INDIANA DEPARTMENT OF TRANSPORTATION

STANDARDS COMMITTEE MEETING

FIRST DRAFT MINUTES

RE: Minutes for the March 18, 2010 Standards Committee Meeting

PROPOSED NEW DRAWING E 715-BDGC-01 ROADWAY DRAIN CASTING PIPE (AS A REPLACEMENT TO AN EXISTING DRAWING E 704-DDCC-05 CAST IRON DRAIN EXTENSION)

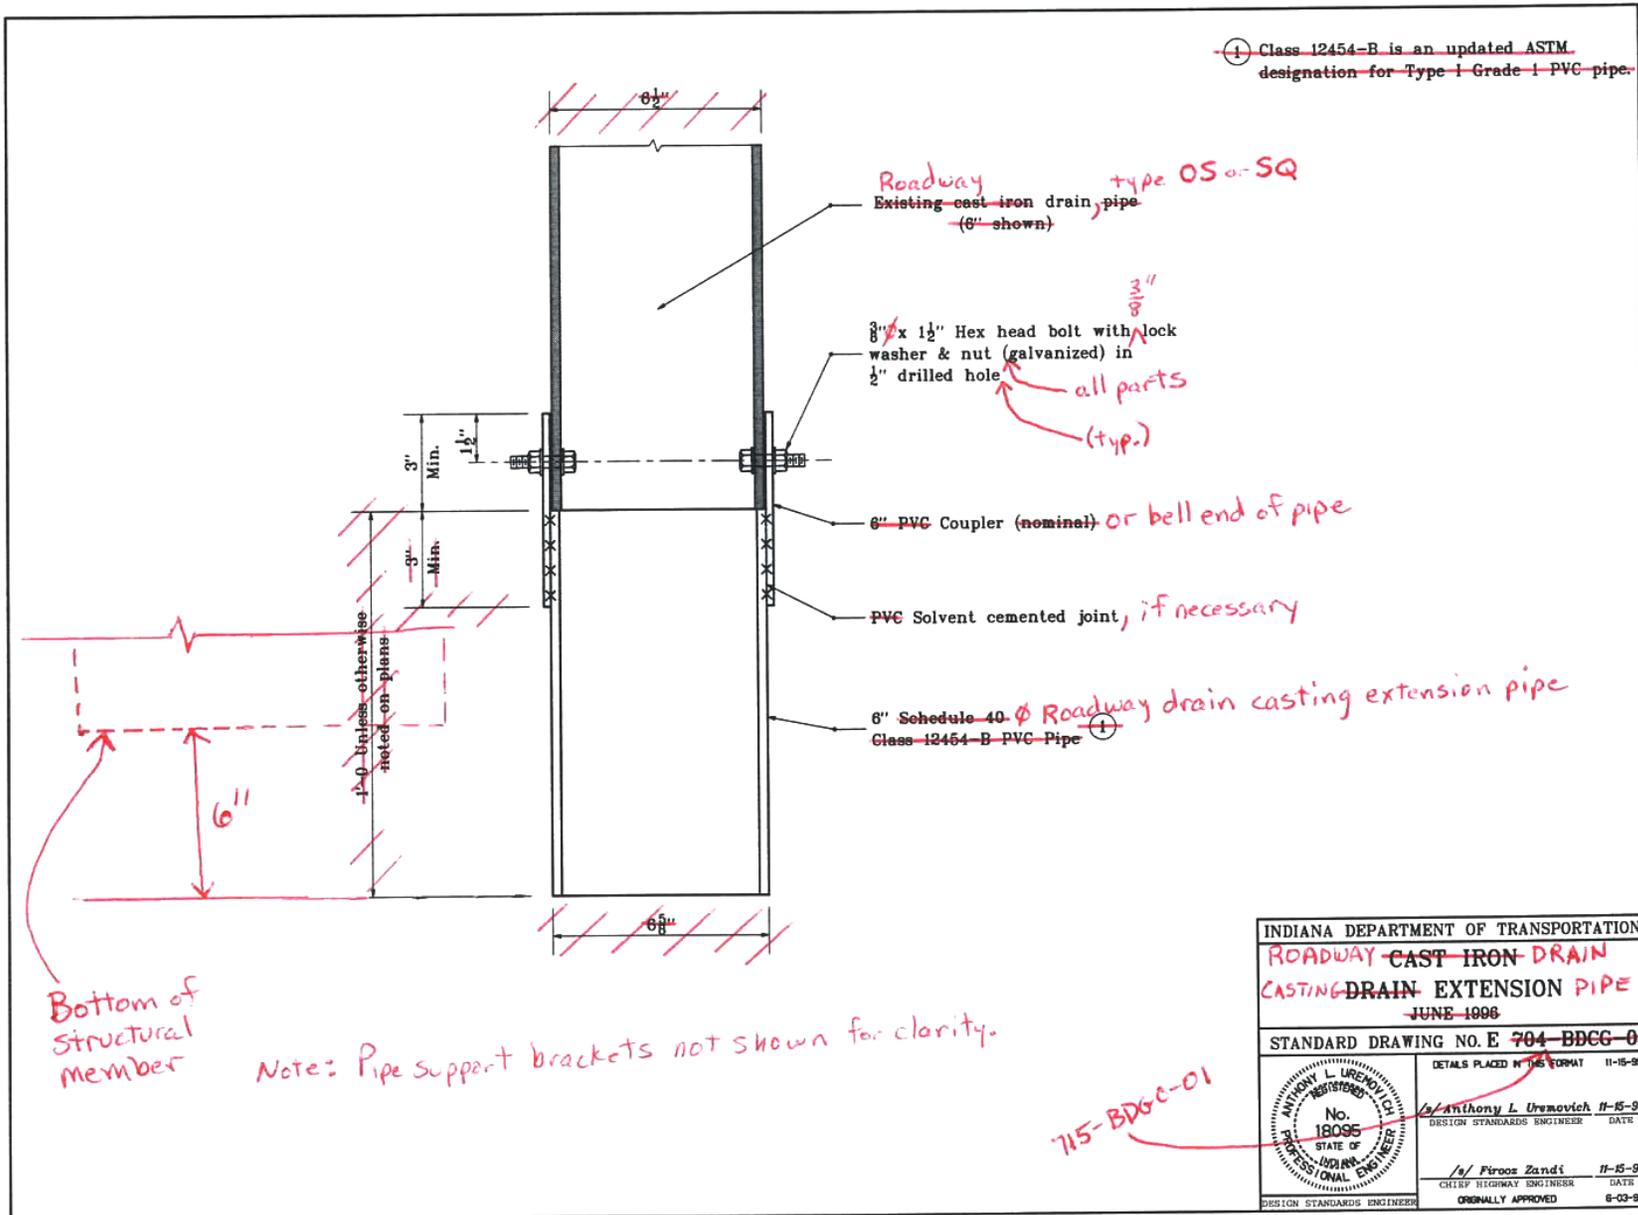
Mr. Reilman then presented the revisions to the standard drawings. There was some concern about stay-in-place metal deck forms, but it was decided that there is generally no stay-in-place forms on the overhangs, and if there were to be, there could be cut-outs for the drain. Mr. Uremovich asked if the drawings should be in the 704 or 715 sections. The answer was that roadway drain drawings would remain in the 704 section while the drain extension would move to 715. Mr. Uremovich also asked what the deadline was for standard drawings to be ready for the September update. The answer was that it would have to be on a case-by-case basis. Revisions that do not change or add pay items are not as involved as new drawings and a design memo can always be issued.

REVISION TO E 714-BCJT-01 PRECAST REINFORCED CONCRETE BOX SECTION JOINT

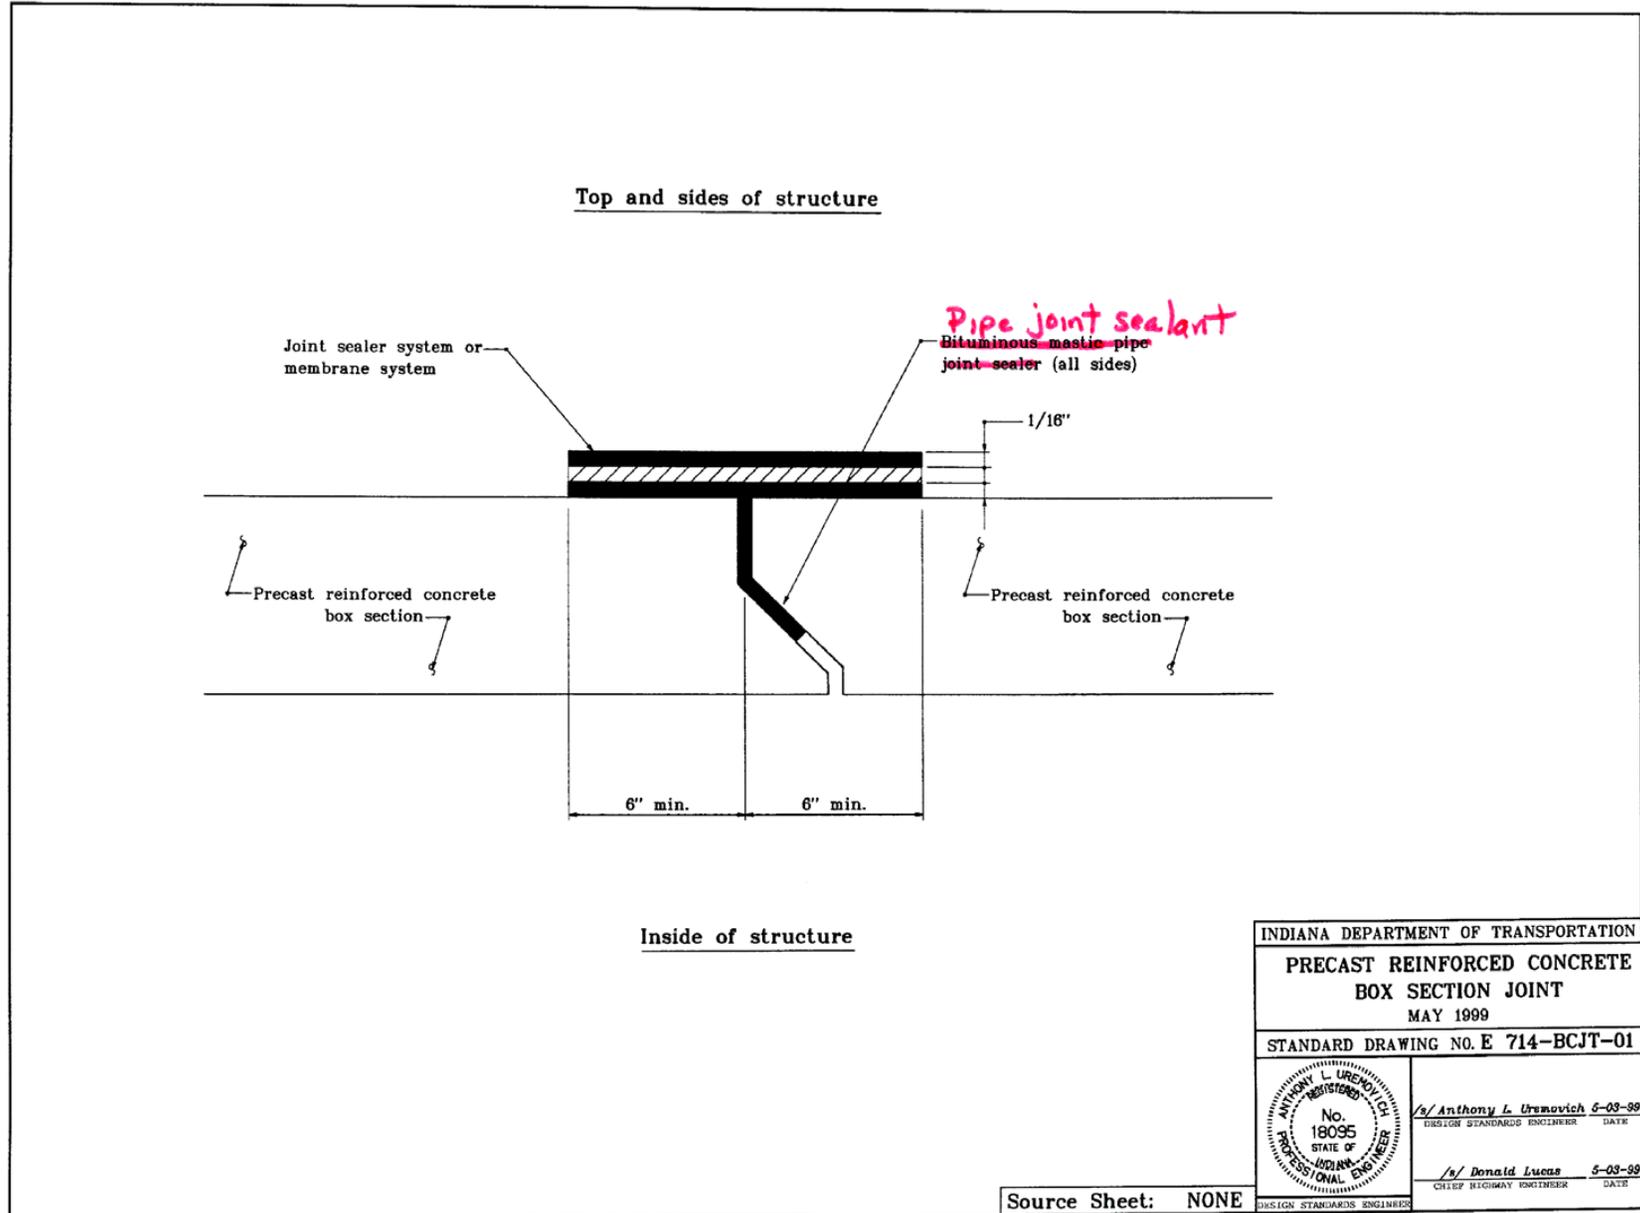
Precast reinforced concrete box section joints shall be sealed as shown on the plans. A ~~bituminous mastic pipe joint sealer~~ sealant system or self-adhering joint membrane systems shall be applied once the concrete surface temperature is above 40°F (5°C) or sufficient to allow adherence. The concrete surfaces shall be cleaned and dry prior to application of the ~~mastic or membrane~~ material. Heat may be applied to the concrete surfaces until they are in accordance with the temperature and dryness requirements. The mastic or membrane material shall be centered on both sides of the joint as it is being applied. After application, the geotextile or membrane material shall be rolled to avoid wrinkling. If the roll of geotextile or membrane material does not cover the full length of the joint, an overlap of at least 2 1/2 in. (65 mm) will be required to start the next roll of material. The manufacturer's application instructions shall apply in addition to the above requirements.
